[Docket No. NHTSA-98-4511; Notice 1]

Federal Motor Vehicle Safety Standards; Platform Lift Systems for Accessible Motor Vehicles Platform Lift Installations on Motor Vehicles

ACTION: Supplemental notice of proposed rulemaking (SNPRM); correction.

FIGURE 2

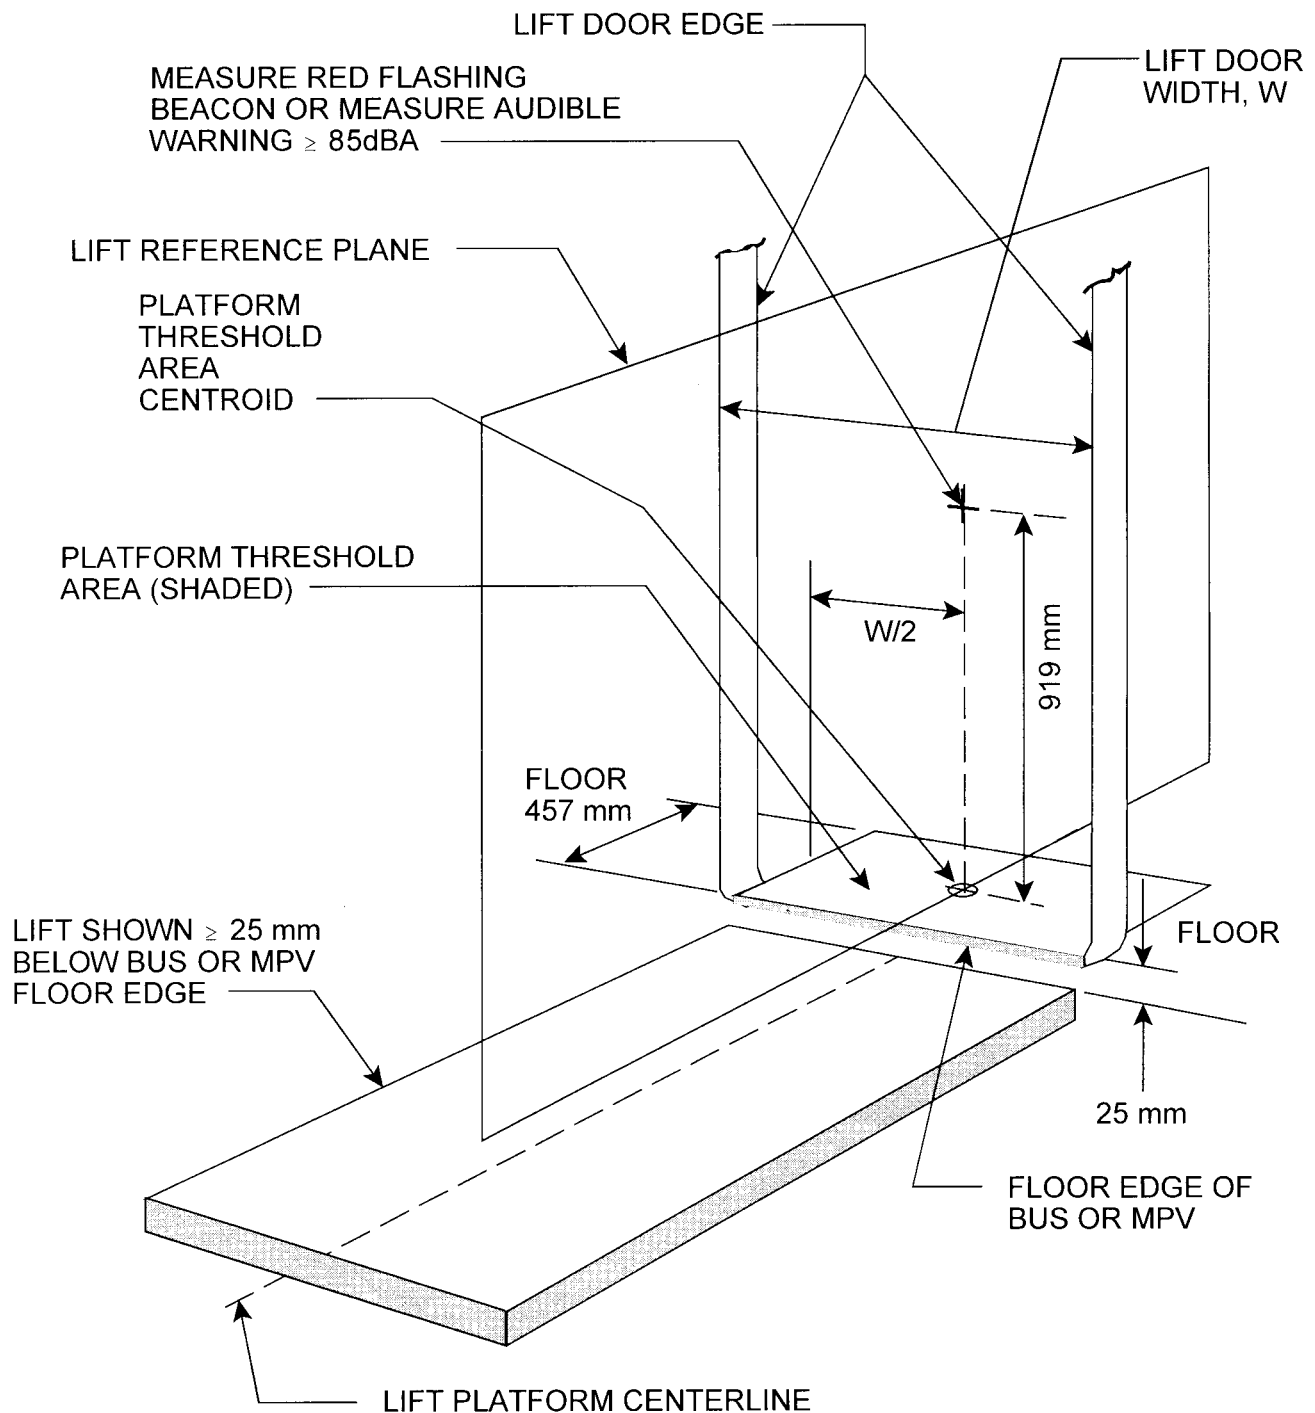
2. On page 46249 in the third column, S5.1.2.4 references a figure 3. The correct reference is to figure 2.

4. On page 46257, figure 2 is missing. Figure 2 is provided in this correction notice.
